Service-Information Motorcycle

Group: 32
Steering

July 1986
32 005 86
(2224)

Recall Campaign 86V-80: Inspection/Replacement of K-Model Throttle Cables

Fig. 1

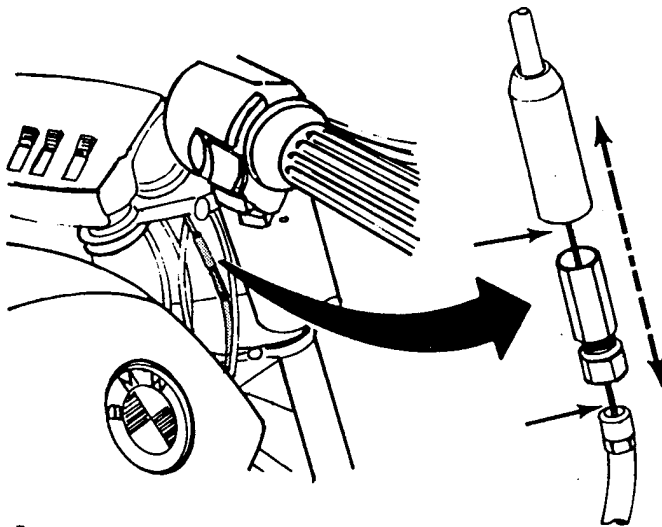
Inspect each throttle cable support-to-throttle cam alignment or look for a visible bend or kink in the braided cable. If support-to-throttle cam misalignment is detected, or if the throttle cable shows any signs of chafing or wear at the positions shown in Fig. 1 or Fig. 2, replace the cable and cable support (see Fig. 3). Follow throttle cable replacement procedures below.

Visually inspect the lower throttle cable at the throttle body. Inspect the upper and center section of the cable (see Fig. 1). Important: Do not bend or twist the throttle cable when checking the upper and center sections.

Fig. 2

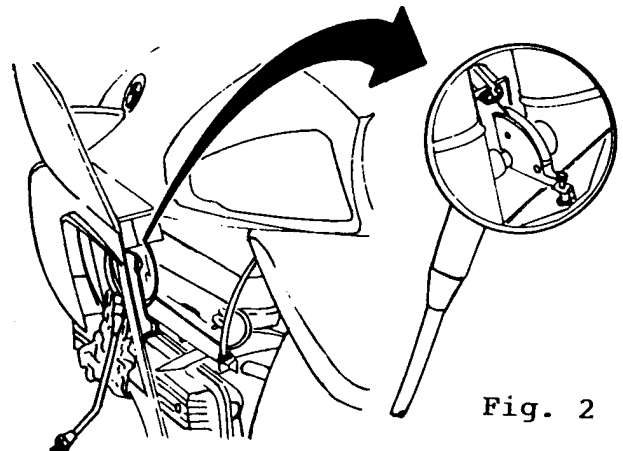
Remove the left knee pad, place a mirror in the louvers and support it with a rag (see Fig. 2). Visually inspect the lower throttle cable at the throttle body, using a flashlight, while operating the throttle twist grip. Inspect the upper and center sections. Important: Do not bend or twist the throttle cable when checking the upper and center sections.

Model: K100RT Remove the left knee pad and air deflector. Place a mirror in the louvers and support it with a rag (see Fig. 2). Important: Do not bend or twist the throttle cable when checking the upper and center section.

Fig. 3:
throttle cable support and
throttle cam
(illustrated to show
misalignment)

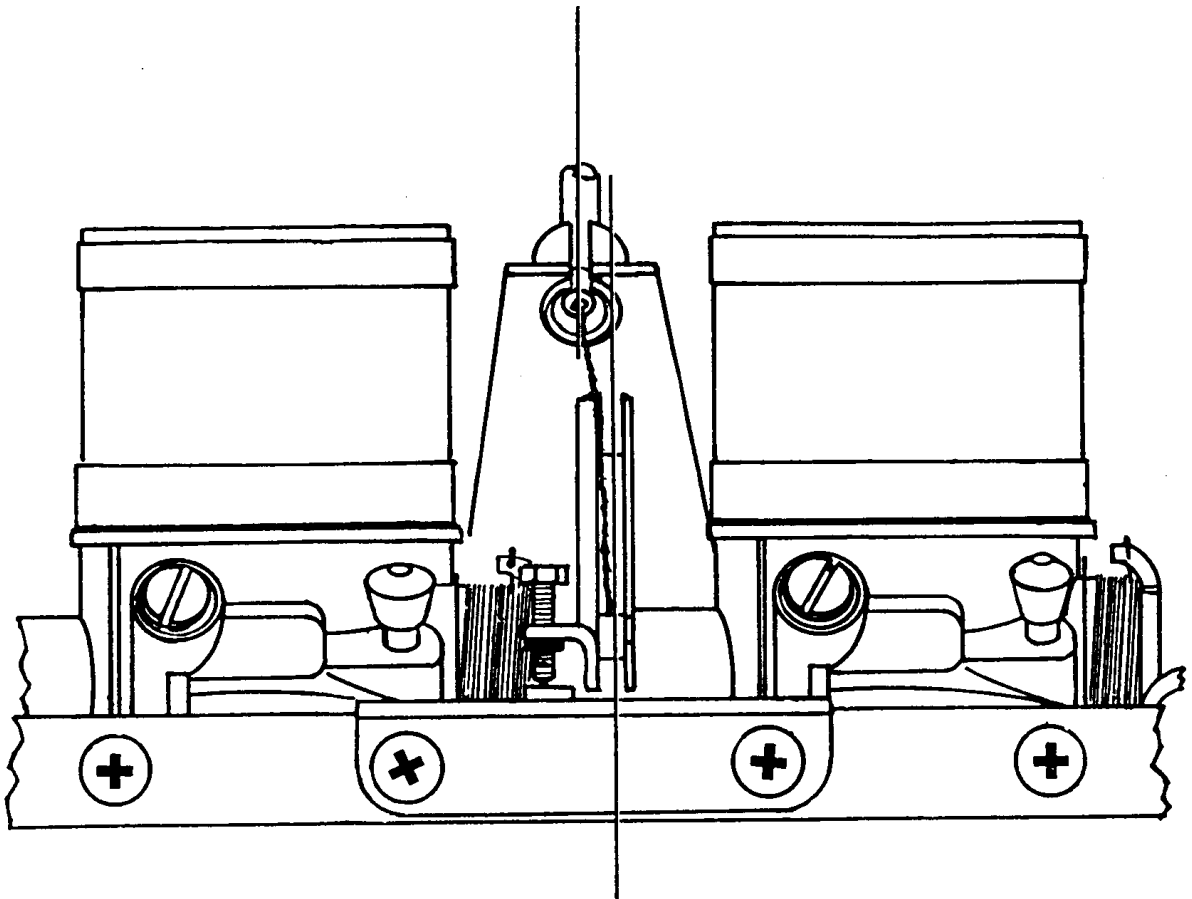
The potential defect involves the throttle cable of the vehicles affected. During production, the cable of a small number of potentially affected vehicles may have been bent during installation (see Note below). This could occur due to misalignment between the throttle cable support (attached to the throttle body assembly) and the cam attached to the throttle valve shaft due to those components exceeding manufacturing tolerances. Since the cable is routed from the support to the cam, as shown in the attached illustration, a bend or kink in the braided metal cable could result. In addition, bending of the cable could also occur at either or both of the two points shown in the attached illustration where the cable exits from the adjustment hardware. In such cases, chafing between the braided throttle cable and the outer sleeve would result in a moderate but detectable increase in throttle operating effort.

Since a small amount of misalignment between the throttle cable support and throttle cam will not adversely affect the throttle cable operation, the following inspection procedure should be followed depending upon mileage:

Inspect for visible bending, kinking or chafing of the braided cable and check for impaired throttle cable operation. If either or both of the foregoing conditions are found, replace the cable and cable support (see Fig. 3). Follow throttle cable replacement procedures below.

- Model: K75C -- Remove the fuel tank and air intake snorkel.
 K75T
 K100 -- Remove the complete air cleaner housing.

-- Remove the support on the throttle housing assembly.

-- Replace the throttle cable.

-- Install a new support and adjust.

Note: Make sure the throttle cable and support are in perfect alignment.

-- Adjust throttle cable play with the handlebar turned right. Maximum play: 1 mm.

Fig. 4

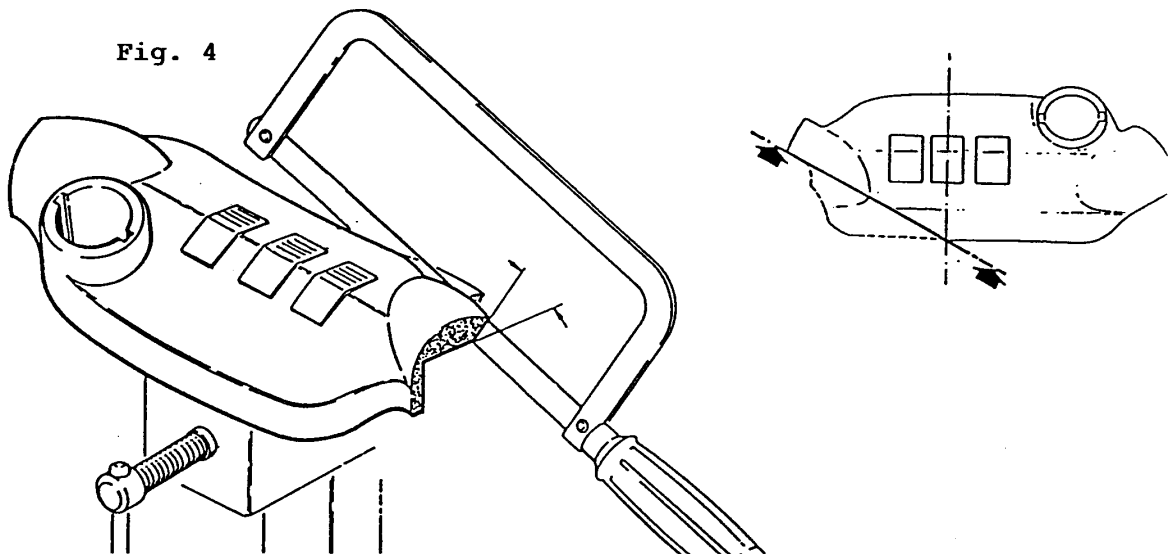
-- Modify handlebar pad (see Fig. 4) and attach it.

As explained on Page 5 of this Service Information bulletin, the handlebar pad requires modification to avoid bends or kinks when the new throttle cable is installed.

Using a metal cutting saw, make a straight line cut according to the drawing below. Smooth the cut edge with a fine file or grinding wheel. Touch up the cut area with black paint.
